SERVICE BULLETIN

APPLICABILITY: 2015-16MY Legacy and Outback Models

NUMBER: 12-192-15R

SUBJECT: Windshield Cracking Concerns

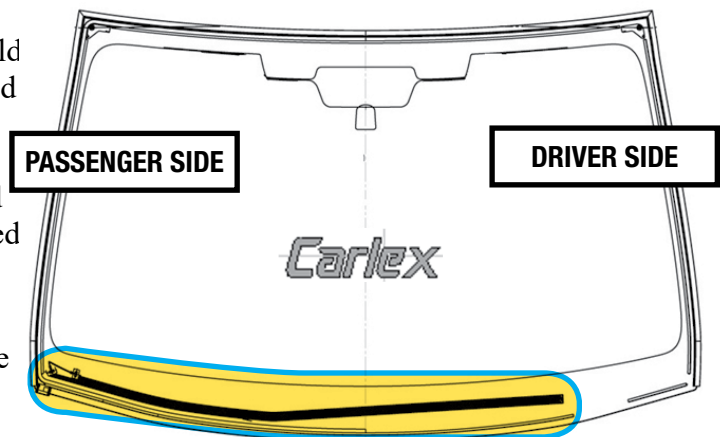
IMPORTANT: The information in this bulletin is only applicable to certain windshield glass manufactured by CARLEX and equipped with the windshield wiper deicer feature (part of the All-Weather Package) on vehicles within the specified VIN ranges. The affected windshields can develop cracks when impacted in the printed black area of the highlighted below.

IMPORTANT NOTE: The illustration to the right shows the windshield as viewed from **OUTSIDE** the vehicle.

Fig. 1

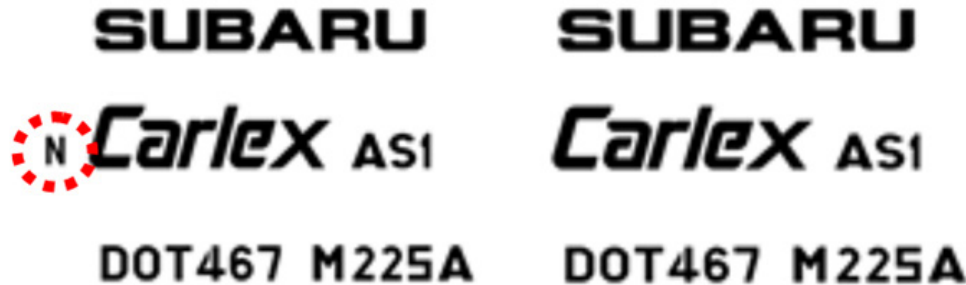
The original windshields (before production change) can be easily identified by the identification markings found in the lower left, driver’s side corner shown in Figure 1 below.

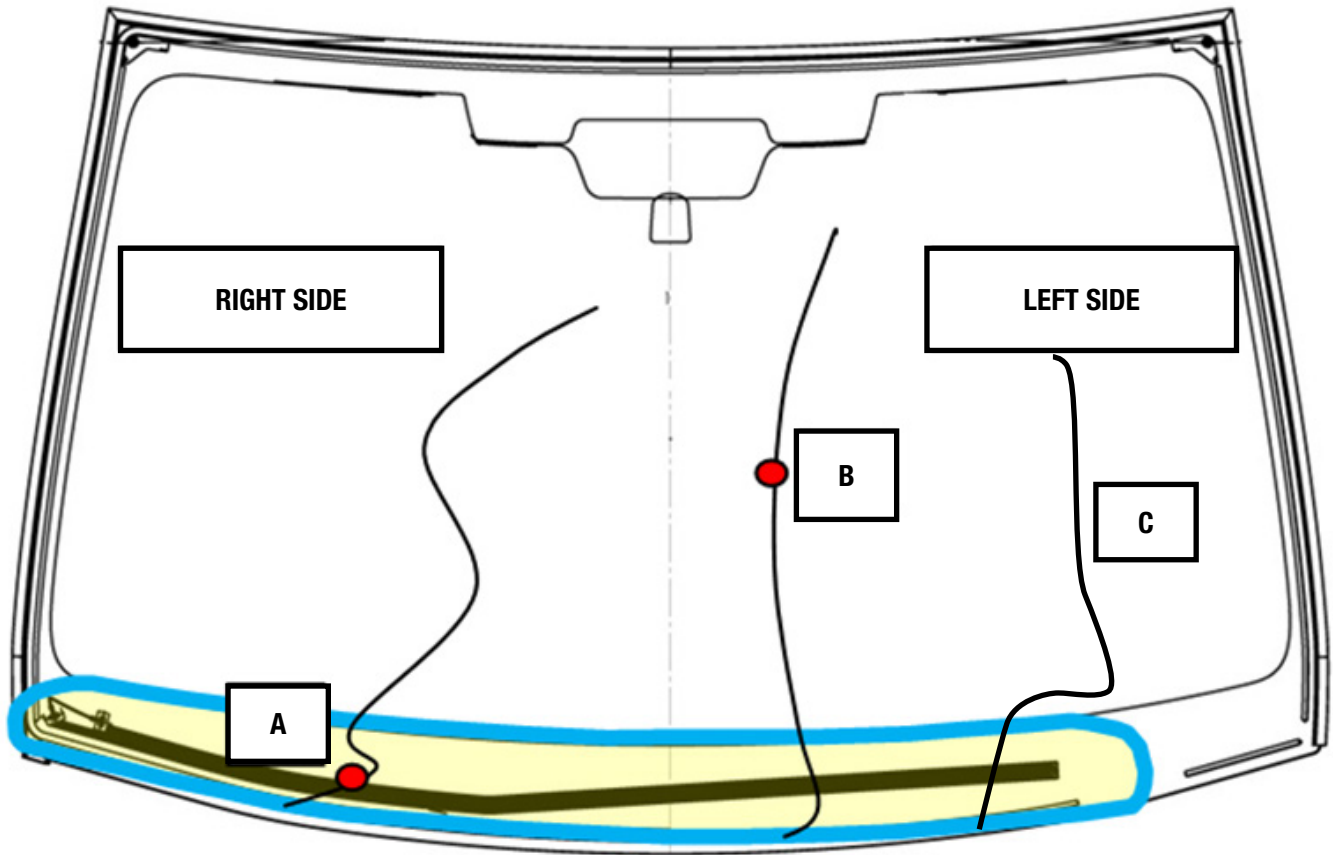
Confirm the windshield is actually cracked and the crack does not originate from a bulls eye, star, or combination impact that appears outside of the deicer region of the windshield (refer to the images in Figure 3 below). Windshields with such impact evidence appearing outside of the deicer region do not qualify for repair under warranty. Bulls eye, star, or combination impacts that appear inside the deicer region of the windshield qualify for the one-time repair under warranty. If there is no evidence of impact, then the crack must pass through the deicer section of the windshield to qualify for the one-time repair under warranty. **DO NOT submit an Authorization Request for a windshield replacement which will be covered by the warranty extension outlined in this Service Bulletin.**

STOP: After confirming the presence of a crack, inspect the manufacturer identification marking in the lower left driver's side corner of the windshield. If the marking is the same as shown in the enhanced production part and replacement part illustrations in Figure 2, this warranty extension DOES NOT apply. These identification markings indicate an enhanced replacement windshield has already been installed.

- If an impact point is found within the affected deicer area (as shown by "A" in the illustration below), proceed with windshield replacement under the terms of this warranty extension.
- If the impact point is found outside of the affected deicer area (as shown by "B" in the illustration below), this bulletin and warranty coverage do not apply.
- If an impact point cannot be identified, and the crack passes through the affected deicer area, the windshield replacement would fall under this warranty extension.
